July 10, 2019

Salinas Valley Basin Groundwater Sustainability Agency
Attn: Gary Peterson, General Manager
peterseng@svbgsa.org
VIA ELECTRONIC MAIL

Re: Comments on Draft Chapter 6 (“Water Budgets”) for the 180/400-Foot Aquifer Subbasin Groundwater Sustainability Plan

**No Data in the Plan for North
Monterey County**

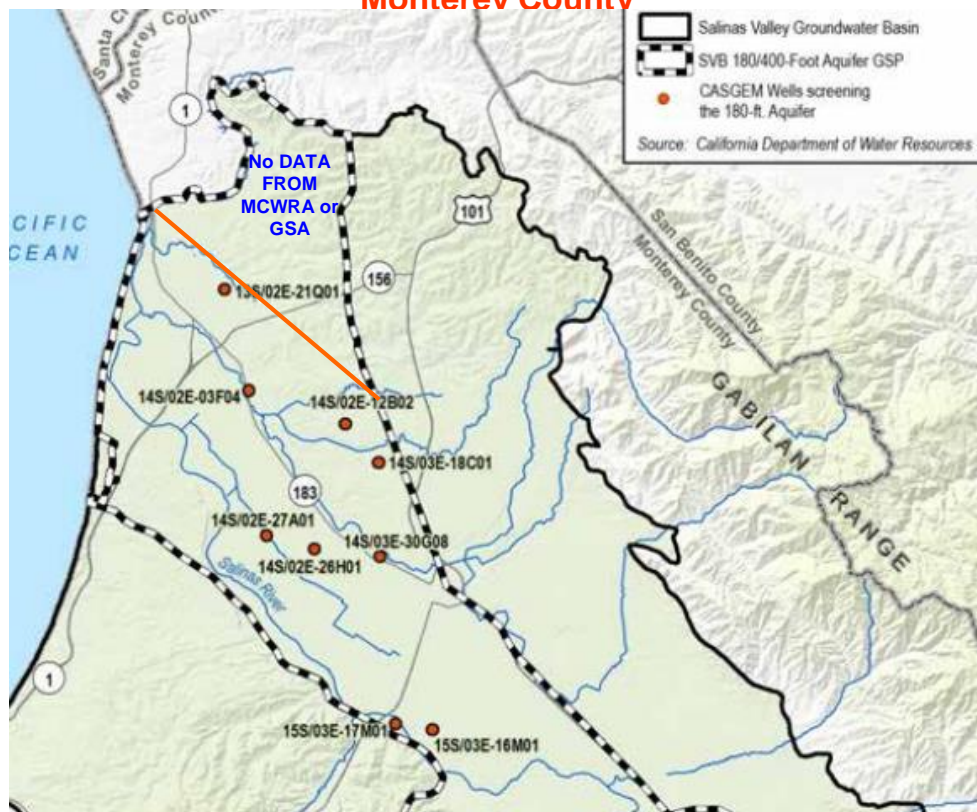
2). In the chapter regarding implementation, there needs to be a commitment that by 2022 private well owners and small water system managers will be notified if their well is located in an area where sea water encroachment is intruding, whether the encroachment exceeds state standards or not, based on increases in chloride and total dissolved solids occurring between 1995 through current time.

3). In the chapter regarding implementation, there needs to be a commitment that by 2022 private well owners and small water system managers will be notified if their well is located in an area ground levels have dropped below the minimum threshold or similar criteria that indicates potential at-risk of sanding or failing.
